**ALERT SERVICE BULLETIN**  
**Bell Helicopter** **TEXTRON**

NO. 206L-07-147

**MODEL AFFECTED:** 206L4

**SUBJECT:** FREEWHEEL AFT SEAL P/N 209-340-265-103,  
INSTALLATION PROCEDURES IMPROVEMENT  
OF

Figure 2. Replacement procedures for seal 209-340-265-103

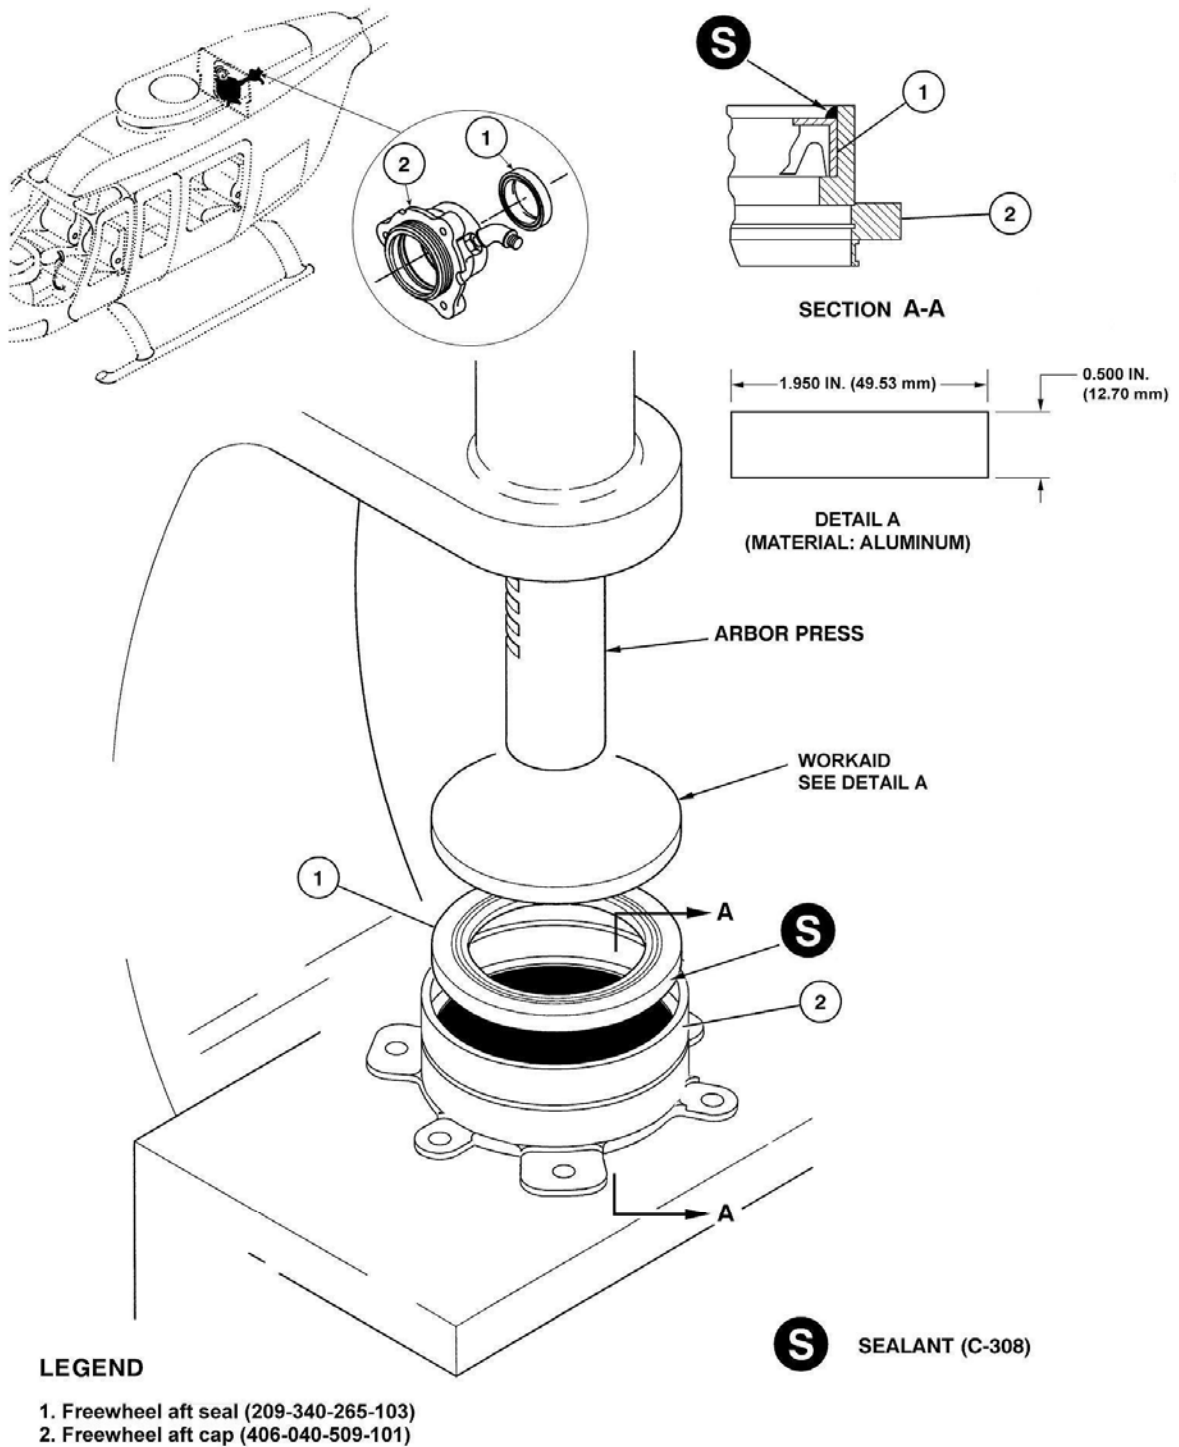
Bell Helicopter has received reports indicating that seal 209-340-265-103 can move outboard from the freewheel aft bearing cap. This condition may lead to an excessive oil leak, which can result in a lack of lubrication at the transmission and the freewheel assembly.

1. Remove aft bearing cap (2, figure 2) (BHT-206L4-MM, Chapter 63).
2. Remove and discard existing seal (1) (BHT-206L4-MM, Chapter 63).
3. Install new seal as follows:
  - a. Clean aft bearing cap (2) and the outer diameter of the seal (1) with solvent (C-316).
  - b. Apply sealant (C-308) to the outer diameter of the seal (1).

**DO NOT USE A HYDRAULIC PRESS TO INSTALL THE SEAL. USE A MANUAL ARBOR PRESS TO CONTROL THE FORCE APPLIED ON THE SEAL FACE.**

- c. While sealant is wet and using work aid (figure 2) push the seal (1) into the aft bearing cap (2) evenly and smoothly until seated.
- d. Fair the squeeze out of sealant (C-308) as shown in figure 2.
4. Complete the installation of the freewheel assembly (BHT-206L4-MM, Chapter 63) and allow time to cure the sealant (C-308) prior to ground run.
5. Perform a ground run for 5 minutes at 100% NR and inspect for leaks.
6. Make a log book entry to show that the PART II of this Alert Service Bulletin has been accomplished.
